Plant Name:  
Three Mile Island #1

Three Mile Island Nuclear Station Unit No. 1  
Docket Number 50-289

RESPONSES TO QUESTIONS RAISED IN ENCLOSURE 2

CONCERNING APPENDIX I

THREE MILE ISLAND UNITS 1 & 2

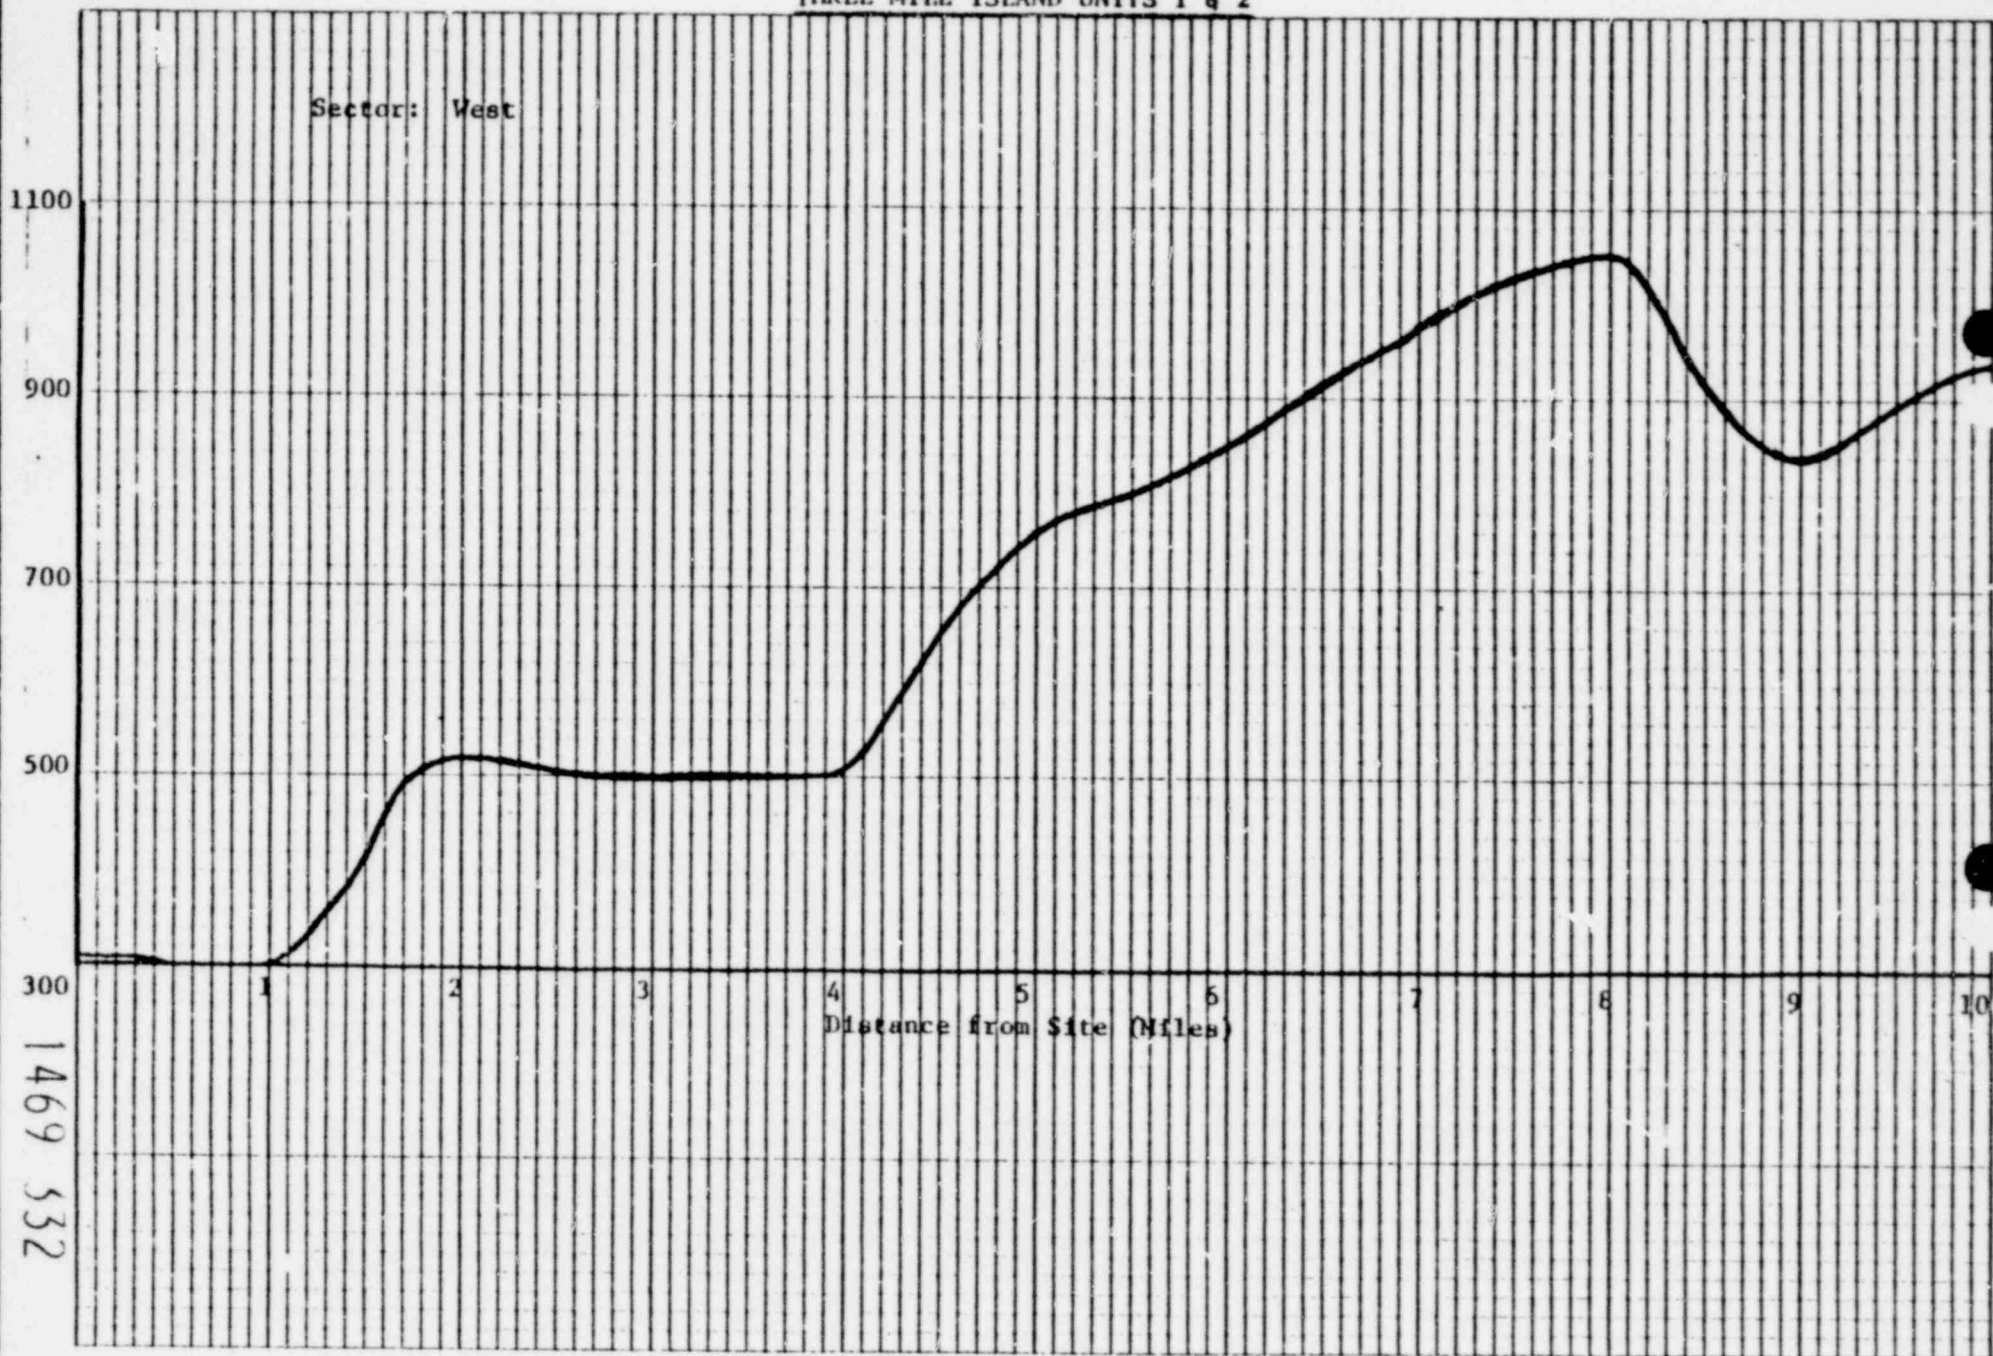
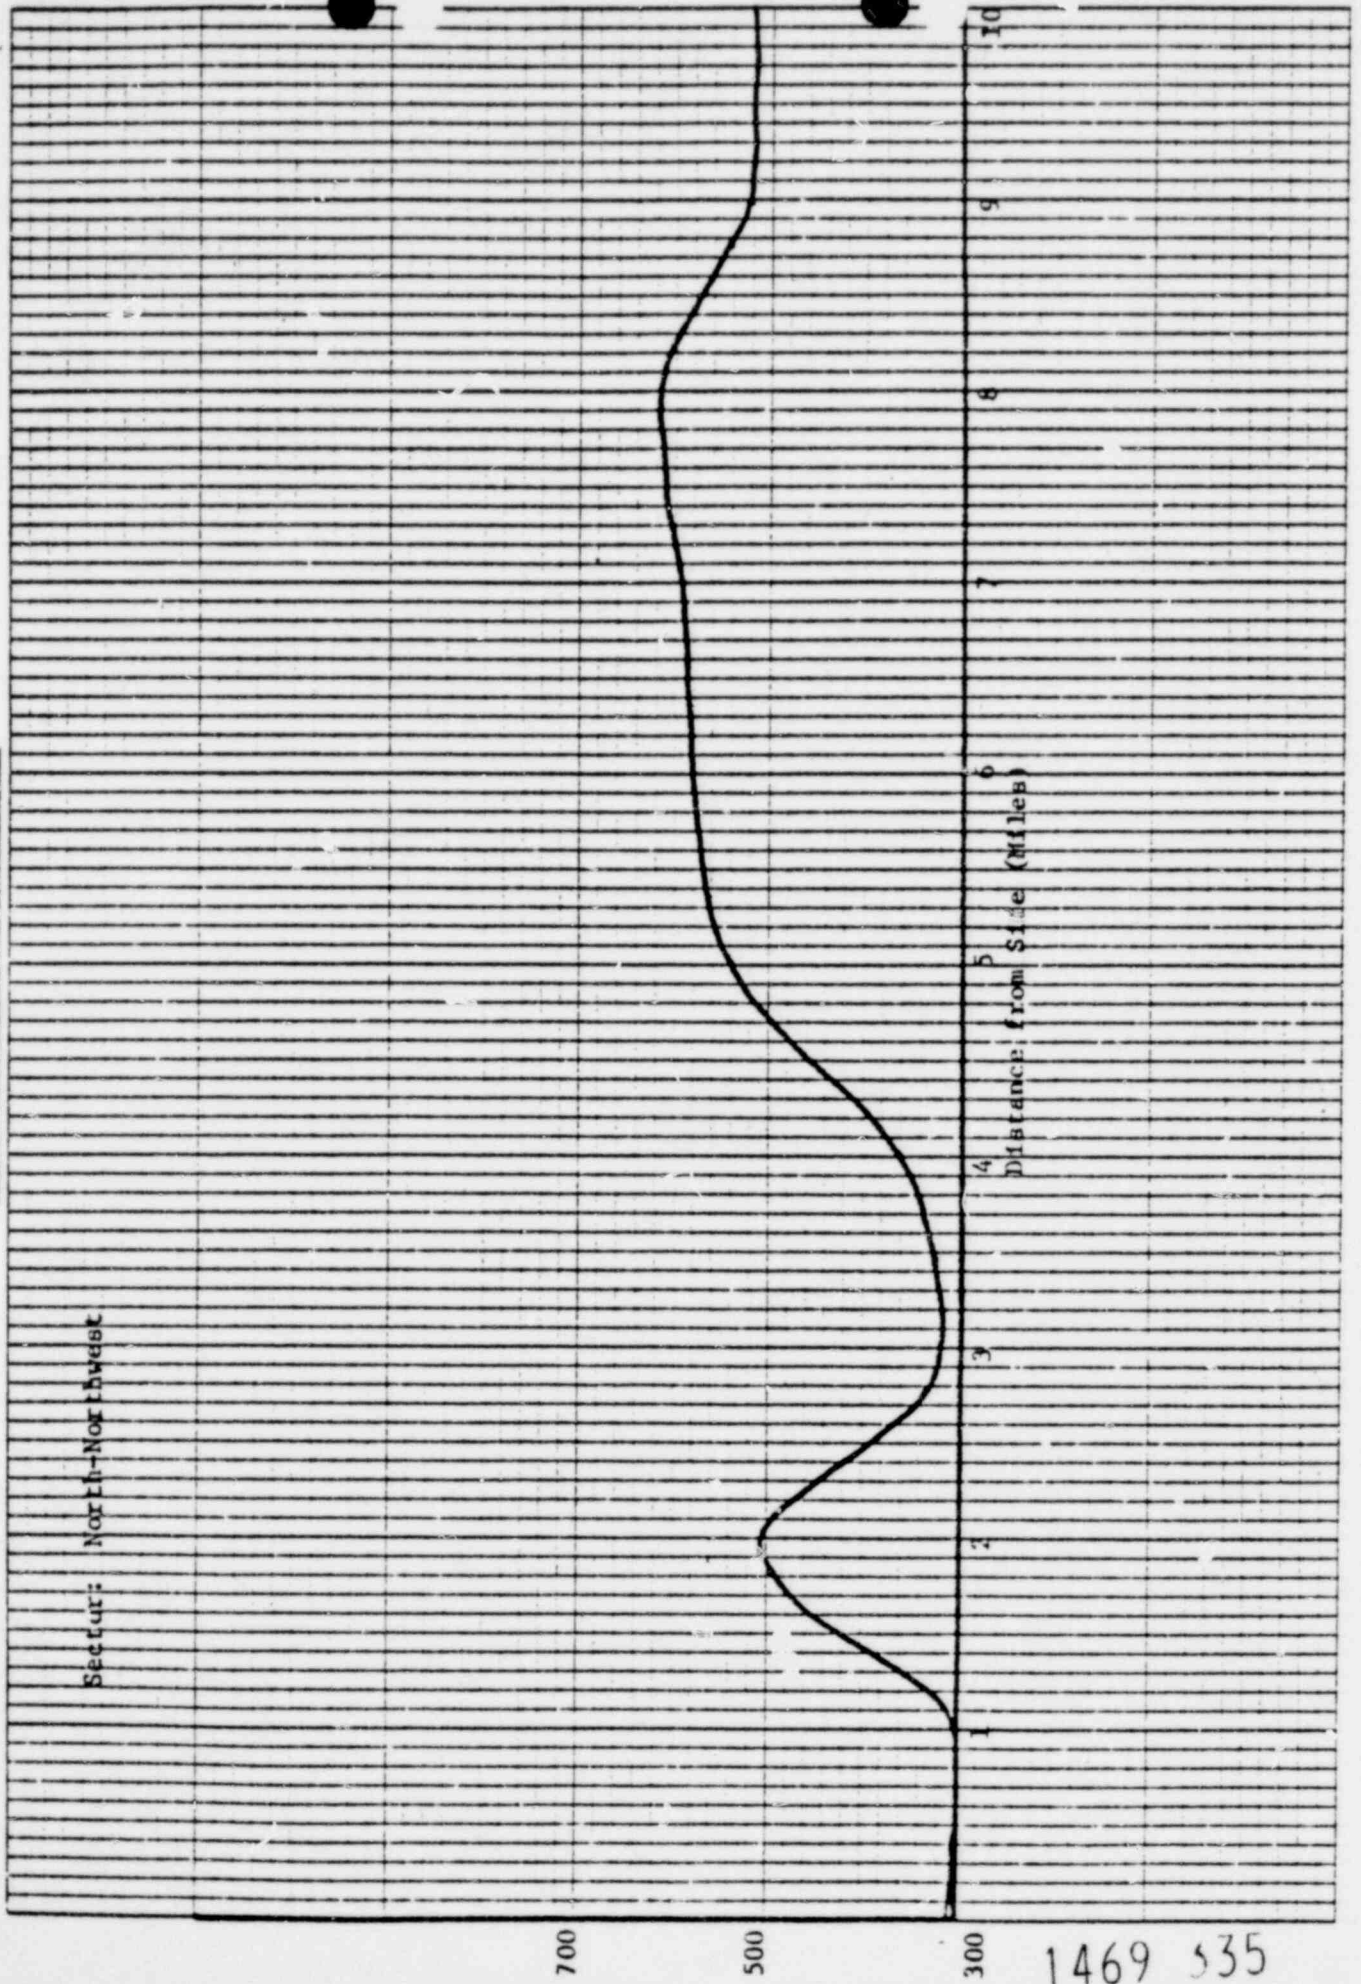
Provide a map showing the detailed topographical features (as modified by the plant) on a large scale, within a 10-mile radius of the plant and a plot of the maximum topographic elevation versus distance from the center of the plant in each of the sixteen 22-1/2 degree cardinal compass point sectors (centered on true north), radiating from the center of the plant, to a distance of 10 miles.

See attached Table 8-1 and Figures 8-1 through 8-16.
